Project	IEEE 802.16 Broadband Wireless Access Working Group < http://ieee802.org/16 >	
Title	The concept of Idle mode operation in IEEE802.16e	
Date	2004-03-11	
Submitted		
Source(s)	Changhoi Koo, Jungje Son, Yeongmoon Son, Seungil Yoon, Seungeun Hong, Jung-won Kim Samsung Electronic, Suwon P.O.Box 105, 416, Maetan-3dong, Paldal-gu, Suwon-si, Gyeonggi-do, Korea 442-742	Mail to : chkoo@samsung.com , jungje.son@samsung.com , ym1004.son@samsung.com , siyoon72@samsung.com , seungeun.hong@samsung.com , jungwon74.kim@samsung.com
Re:	Call for inputs for commentary of p802.16e/D1	
Abstract	This contribution describes Enhanced Handover Mechanism for supporting Active BS Set in IEEE P802.16e/D1-2004.	
Purpose	Discuss and Adopt enhanced feature of p802.16e/D1	
Notice	This document has been prepared to assist IEEE 802.16. It is offered as a basis for discussion and is not binding on the contributing individual(s) or organization(s). The material in this document is subject to change in form and content after further study. The contributor(s) reserve(s) the right to add, amend or withdraw material contained herein.

The Concept of Idle mode Operation in IEEE 802.16e

Figure.108b MSS Awaiting Sleep Response SDL Diagram

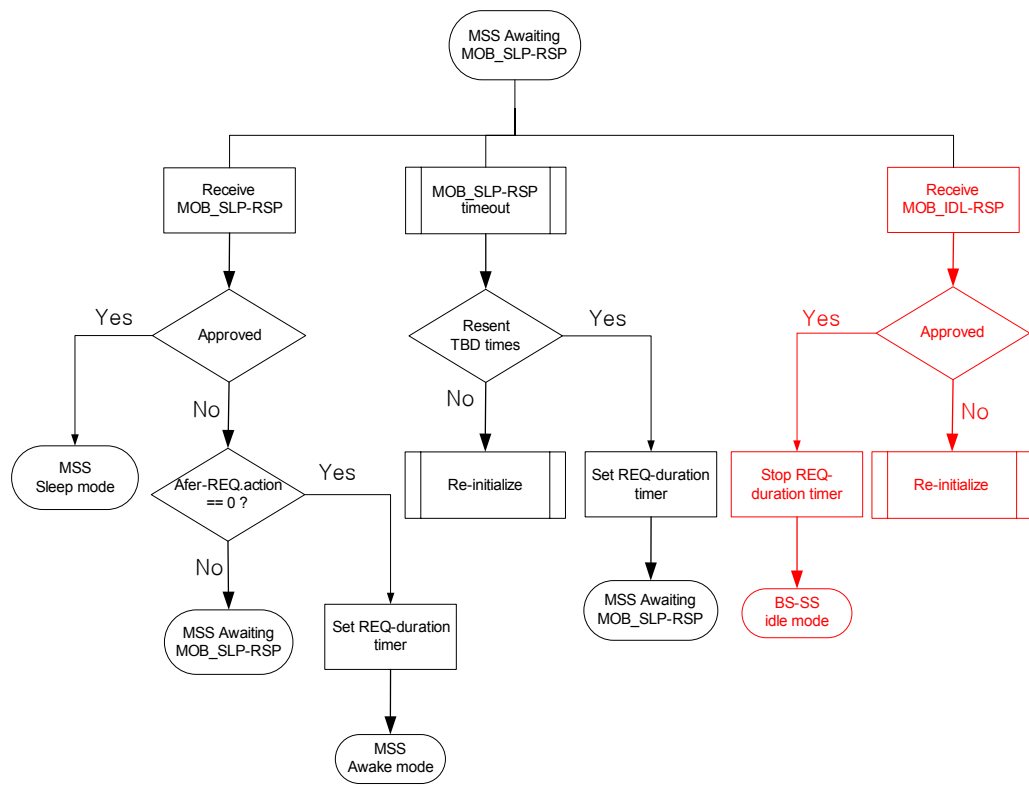
[In Page 38, Line 1, Replace Figure 108b – MSS Awaiting Sleep Response SDL Diagram with the following]

Figure 109d. Typical MSS Listening SDL Diagram

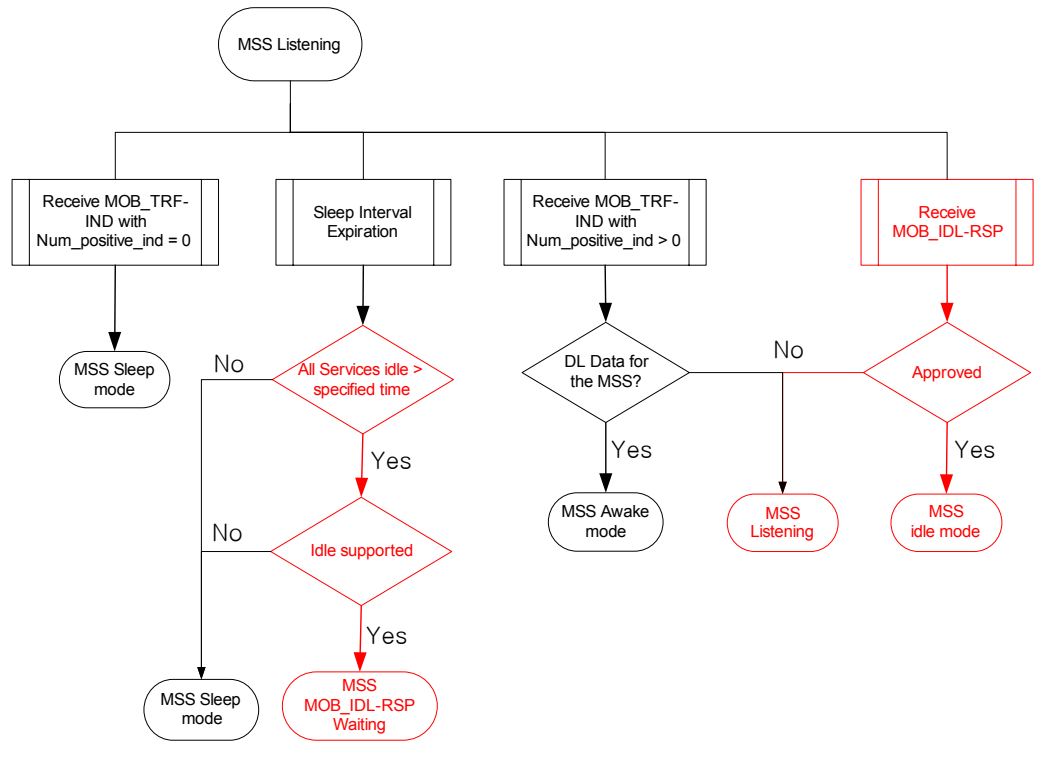
[In Page 38, Line 1, Replace Figure 108d – Typical MSS Listening SDL Diagram with the following]

Figure.xxx - MSS Idle mode SDL Diagram

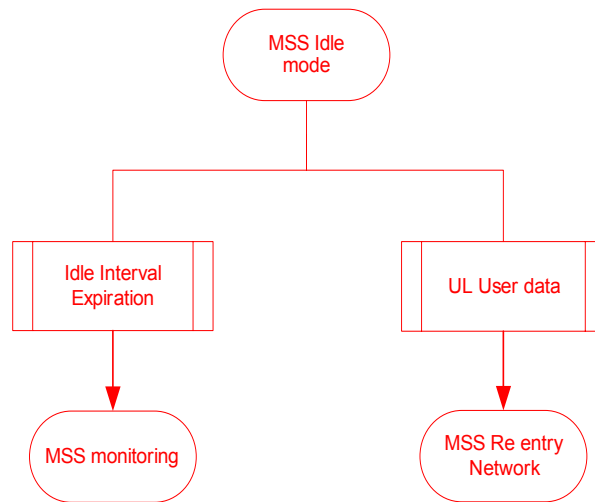
[In Page 43, Line 44, Insert Figures before the section 7.1 Architecture]
